February 3, 2023

**Rainforth Grau Architects Project No.22-1515**  
DSA File and Application No. 39-73 / 02-120733  
PTN: 75499-180

## ADDENDUM NO. 1

Villalovoz Elementary School, Inc. #2  
Tracy, California

DEMO A118 AND A119 VILLALOVOZ ELEMENTARY SCHOOL - TRACY UNIFIED SCHOOL DISTRICT TRACY, CA DSA APP.02-120733	1/A2.1.3-2	DATE: 01/31/23
		PROJECT NO.: 1515
		SHEET: AD1.04

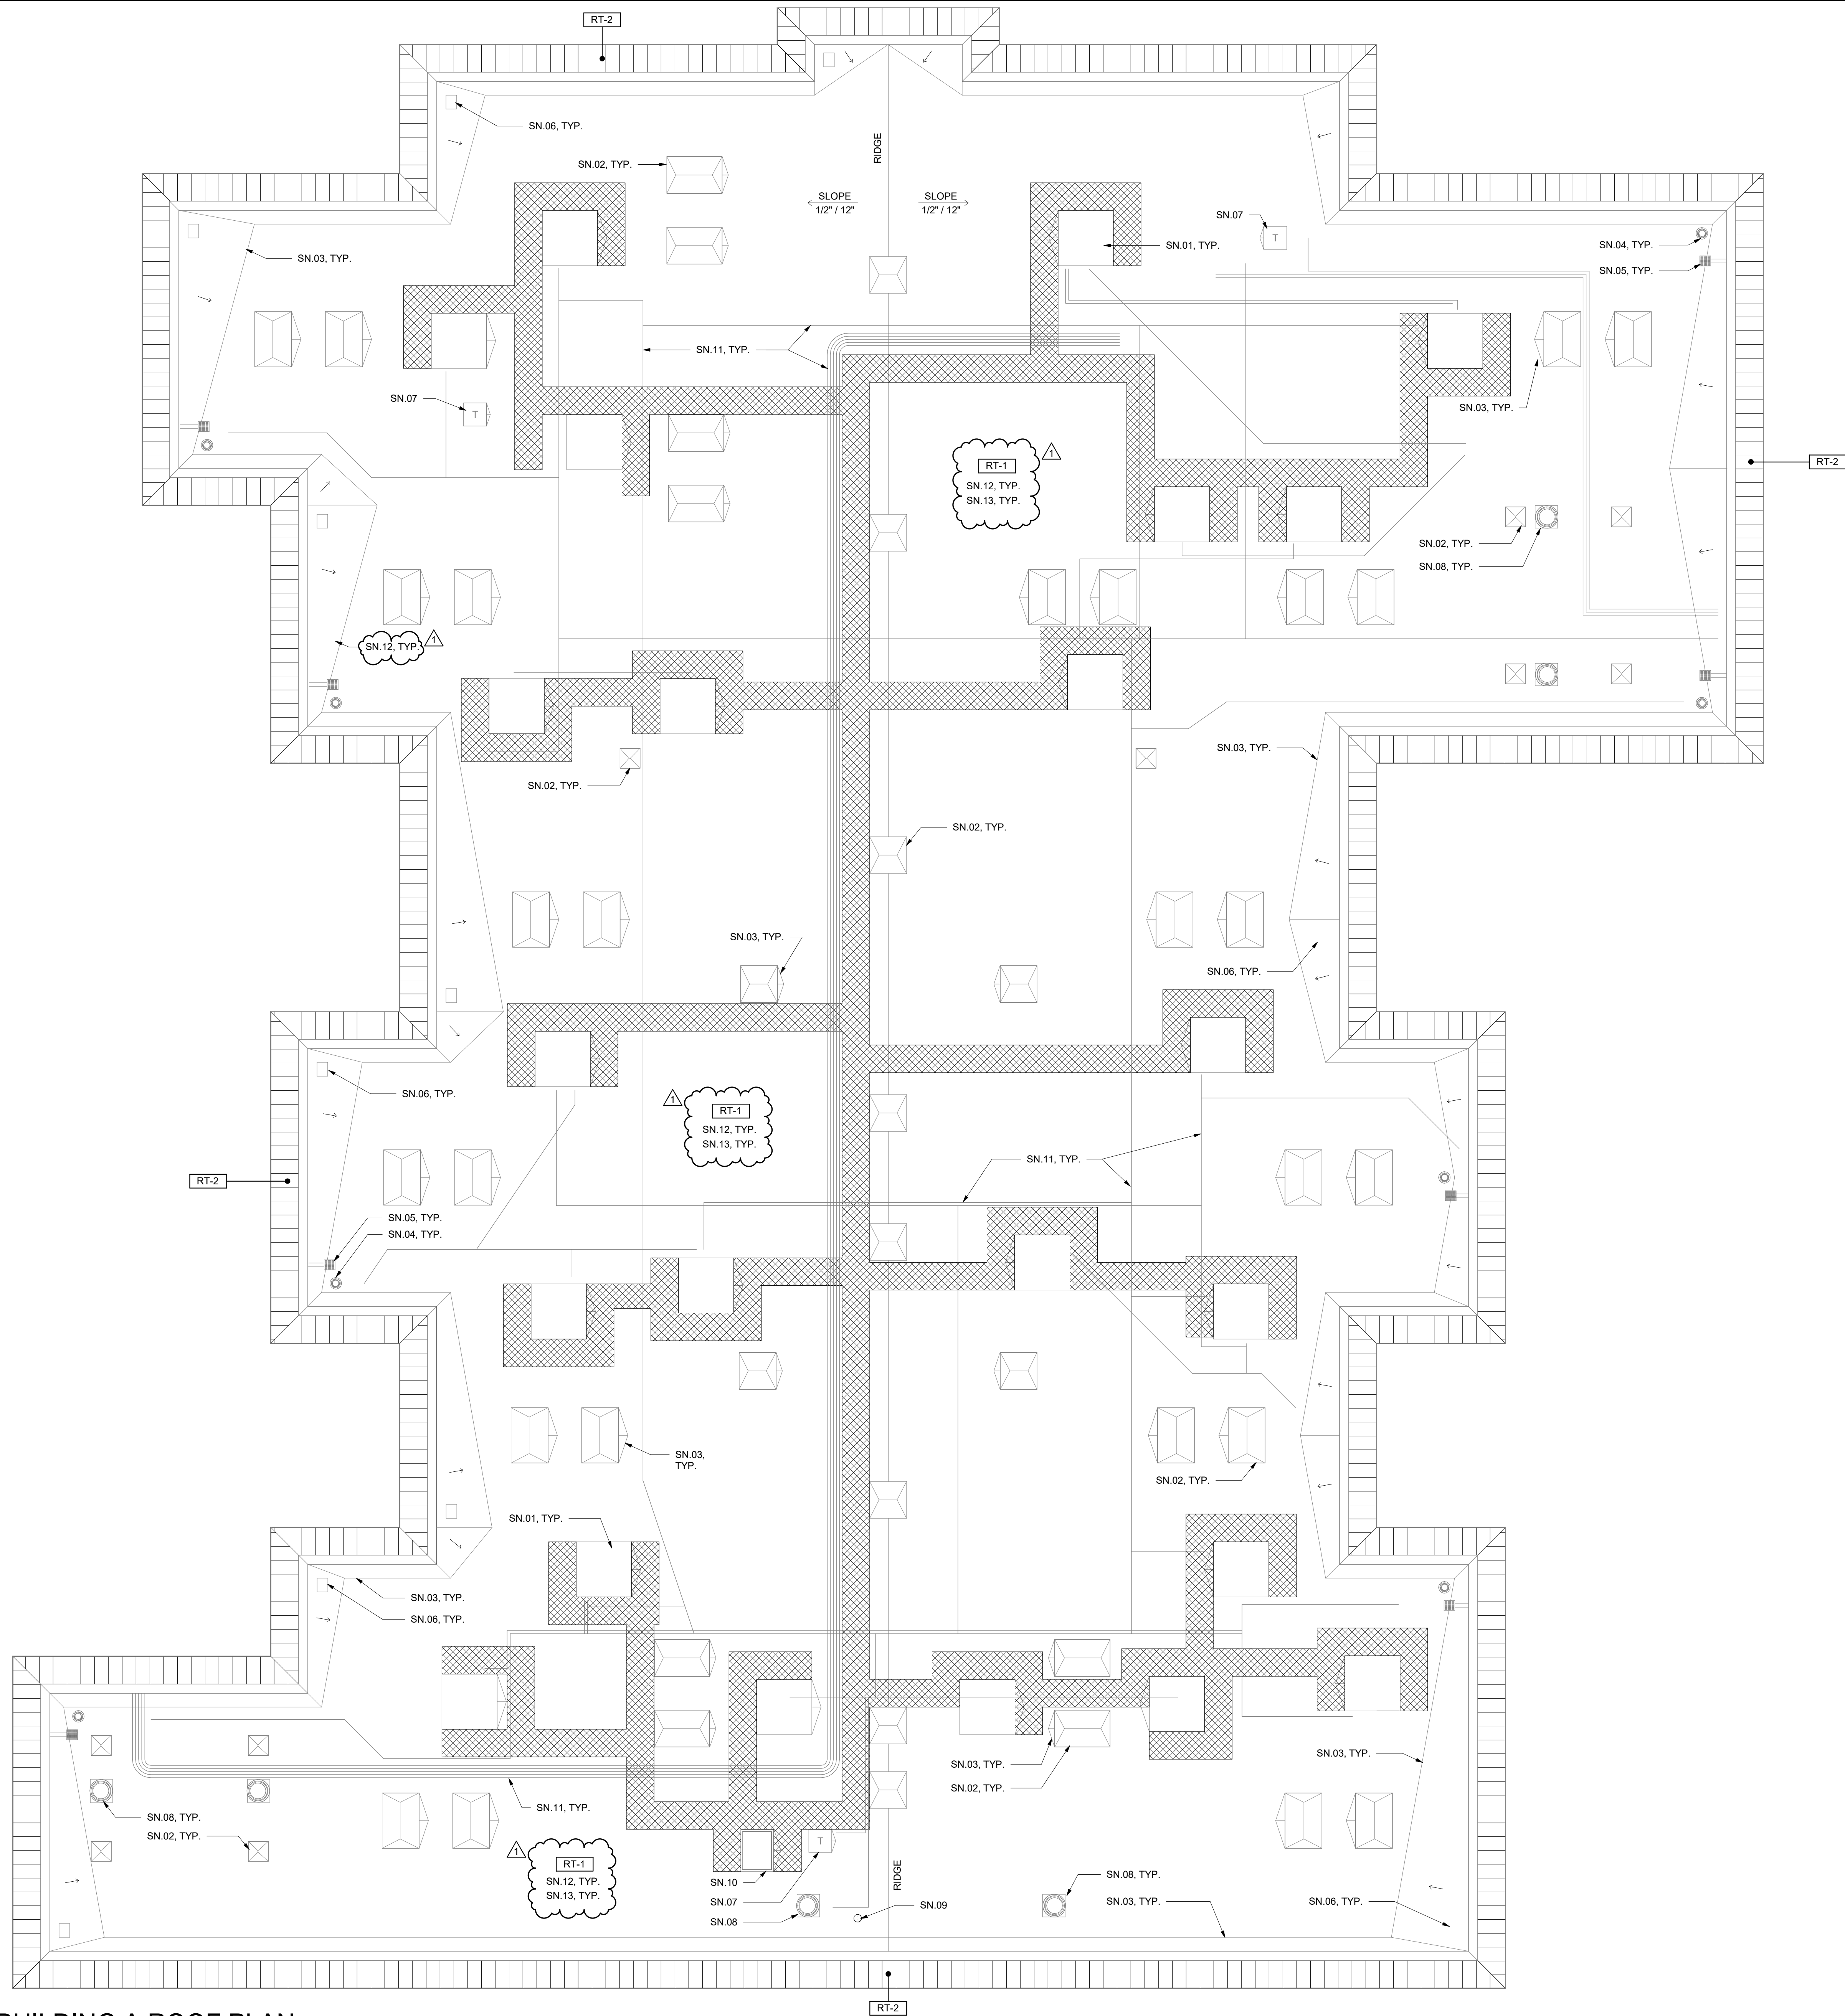
1. REVISE detail 1, BUILDING A – DEMO RESTROOMS A118 AND A119 per sheet AD1.04 included with this addendum.
- E. Sheet A2.1.8-2, ROOF PLAN – BUILDING A
1. DELETE sheet in its entirety and REPLACE with sheet AD1.05 included with this addendum

## ENLARGED FURNITURE FLOOR PLAN

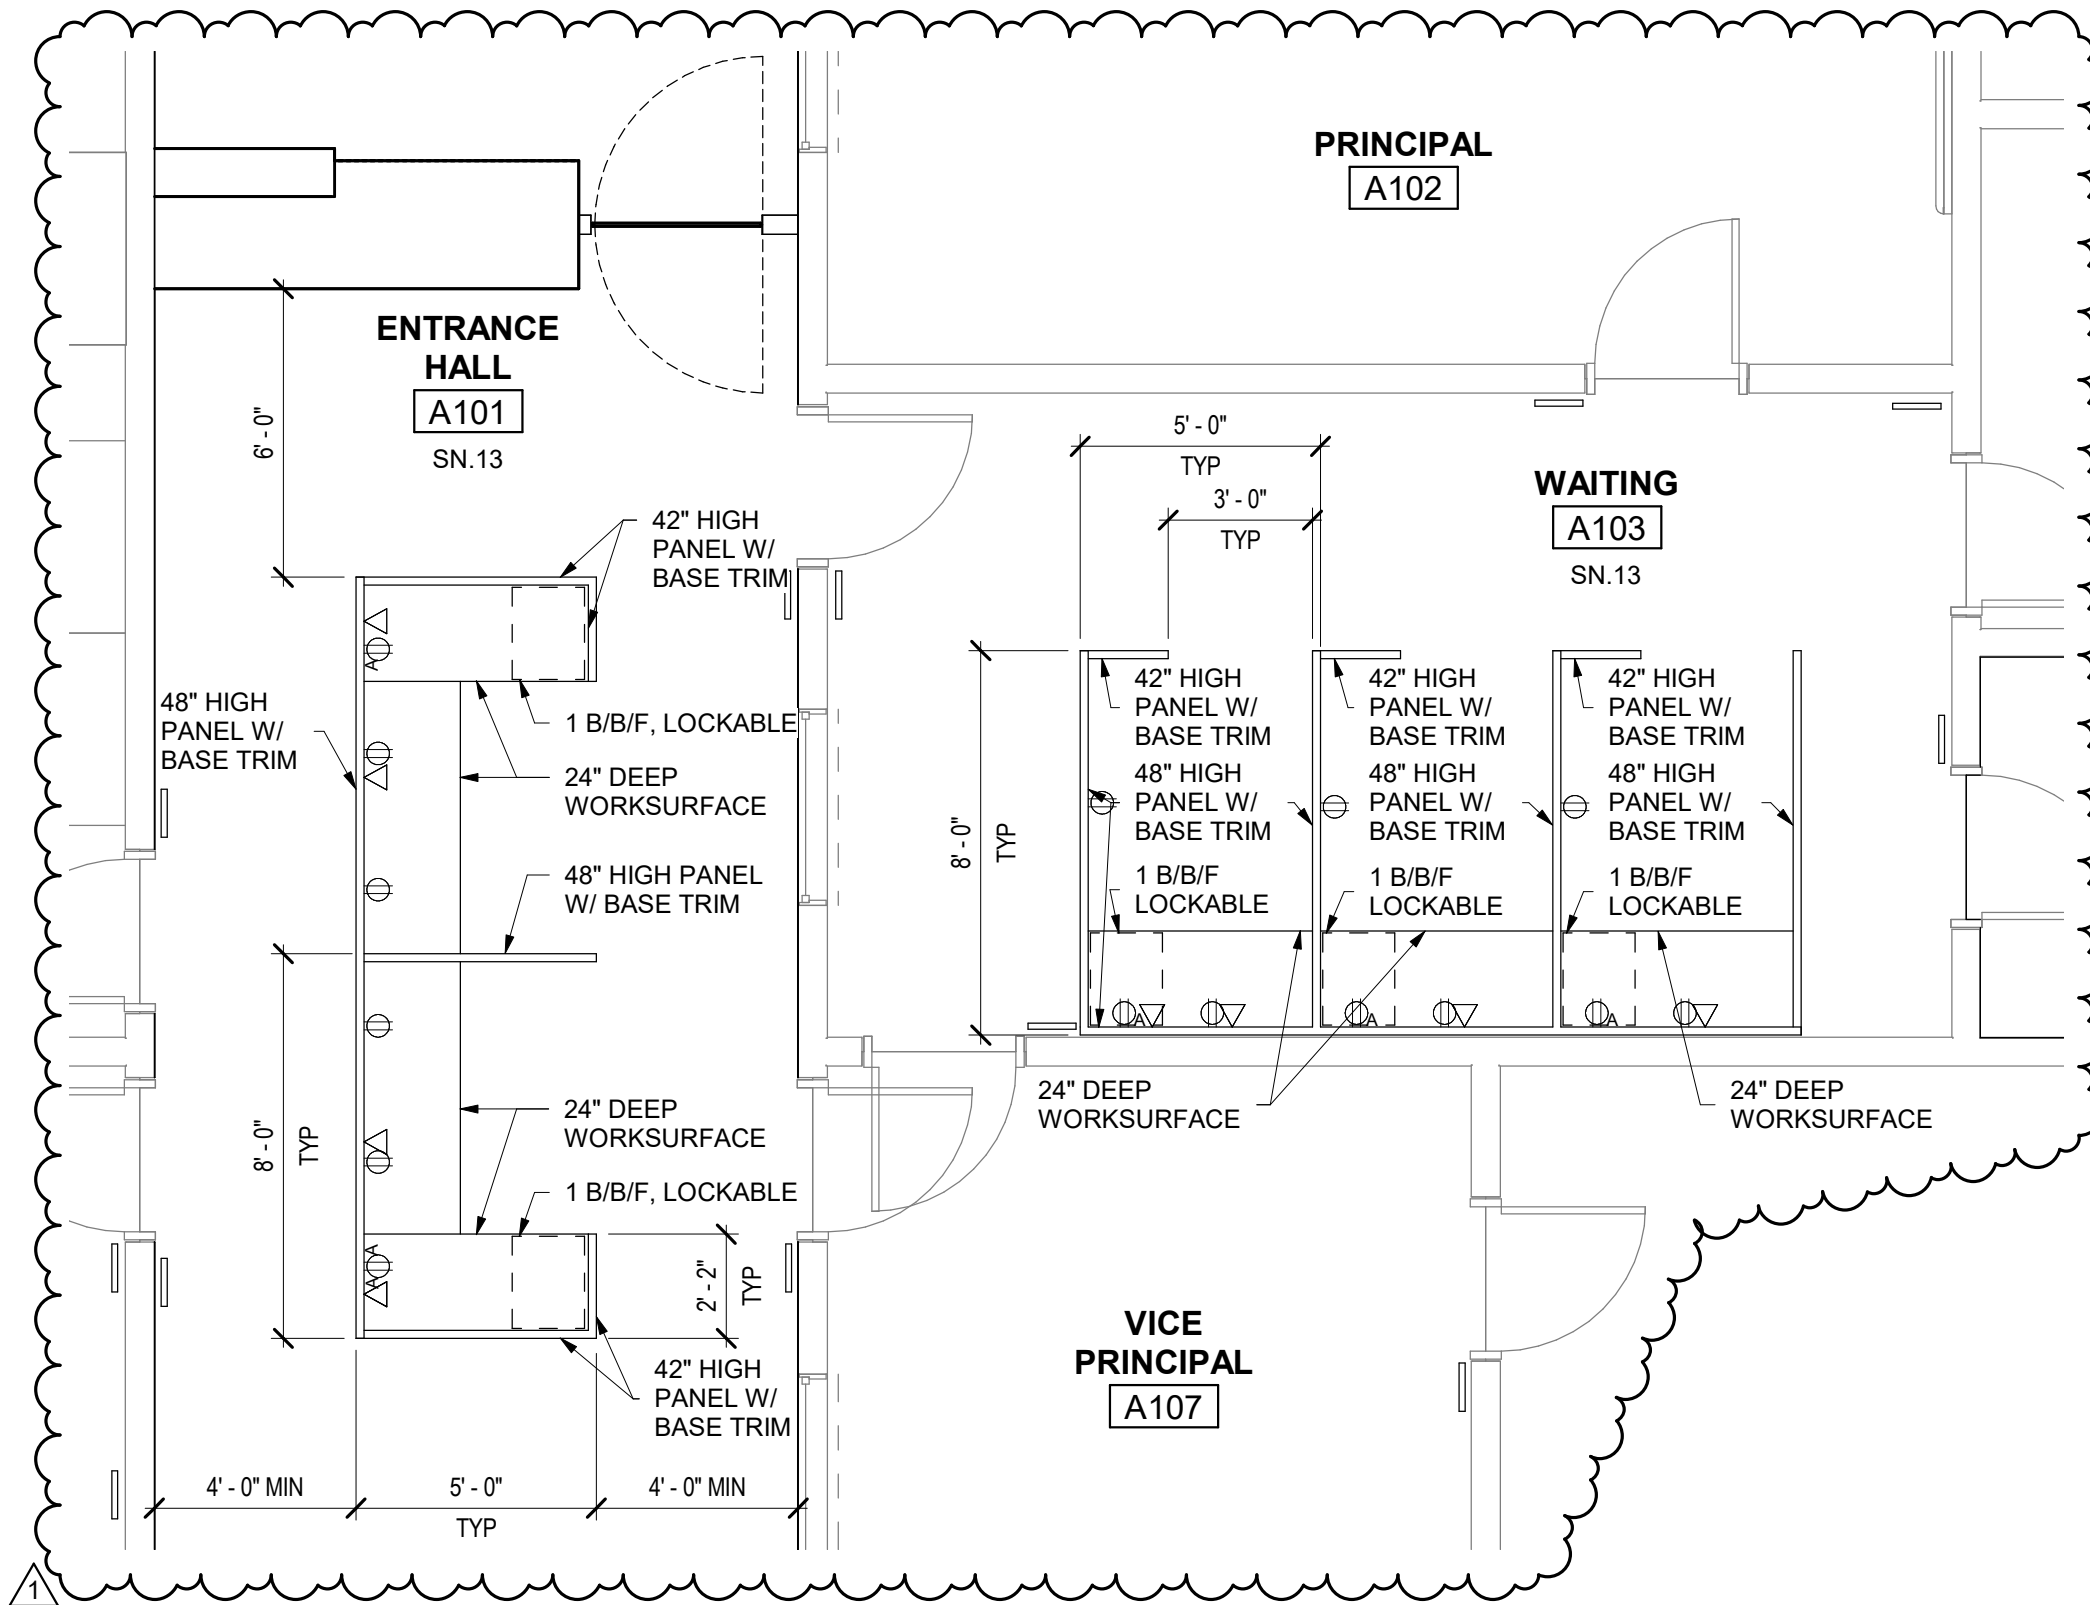
1. DELETE sheet in its entirety and REPLACE with sheet AD1.07 included with this addendum.
- H. Sheet A5.1.4-2, INTERIOR ELEVATIONS – BUILDING A
1. ADD detail 1, FURNITURE FLOOR PLAN per sheet AD1.08 included with this addendum

## A132 CLASSROOM/ A133 ALCOVE

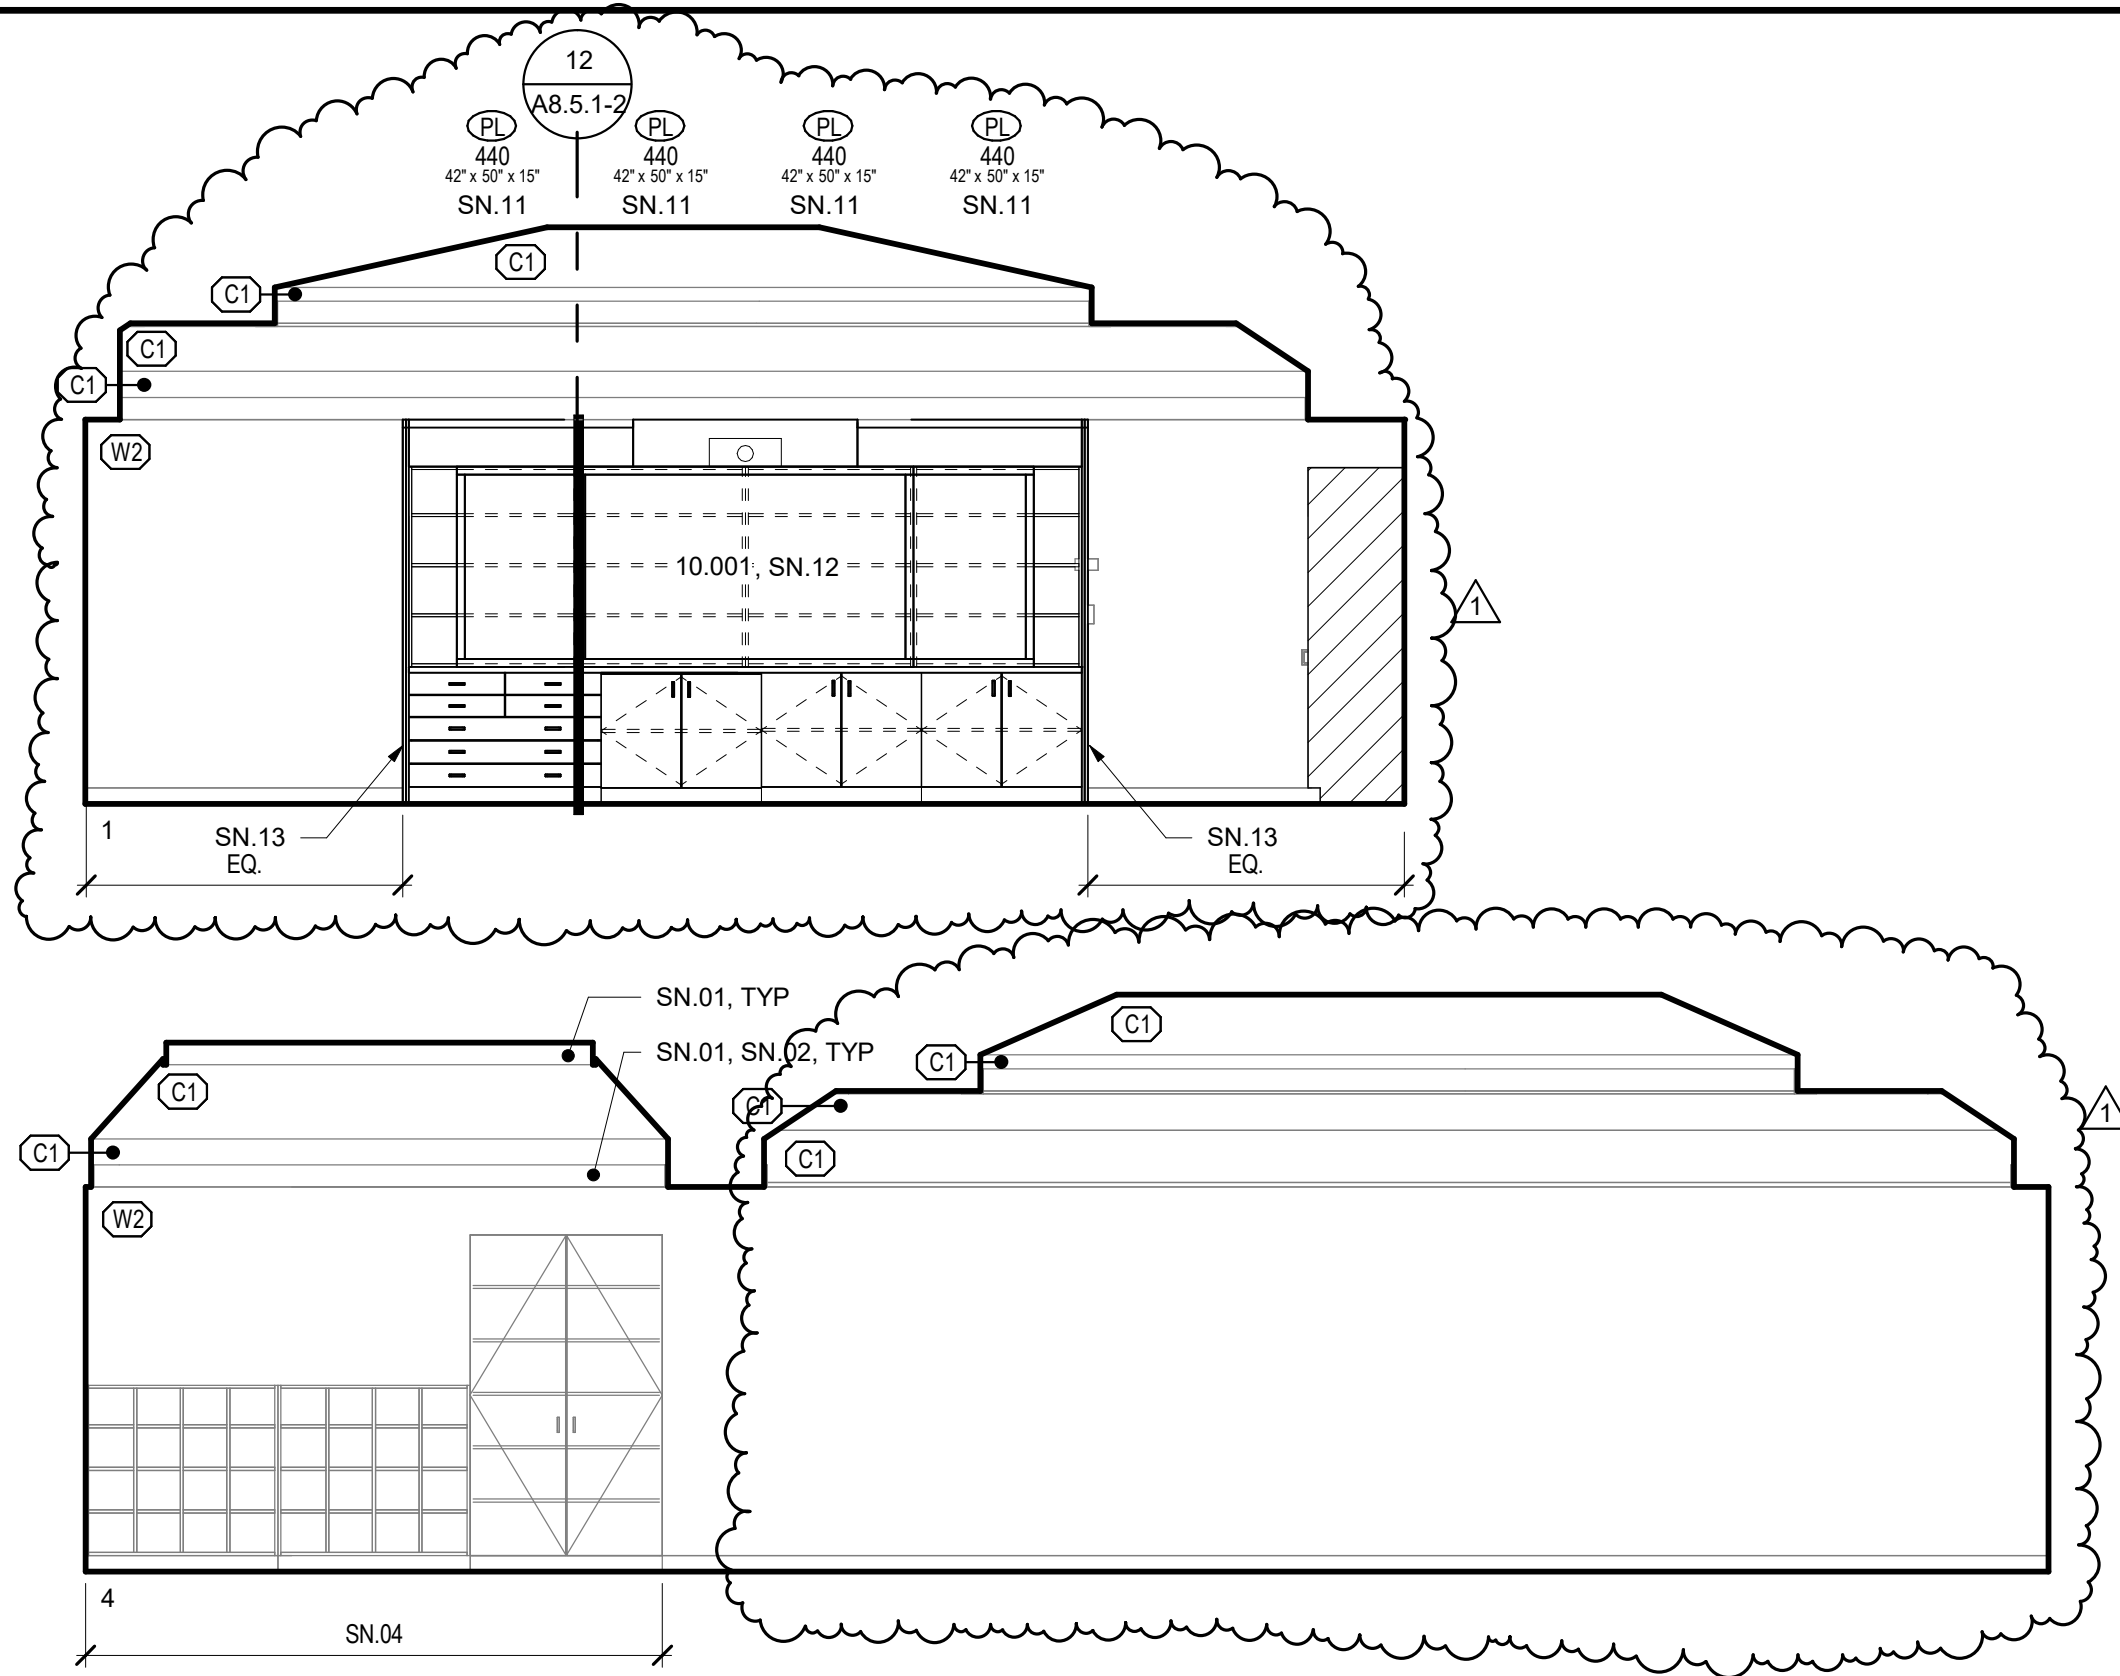
- I. Sheet A5.1.7-2, INTERIOR ELEVATIONS – BUILDING A
1. REVISE detail A132 CLASSROOM/ A133 ALCOVE per sheet AD1.09 included with this addendum.
- J. Sheet A6.2.1-2, REFLECTED CEILING PLAN – BUILDING A
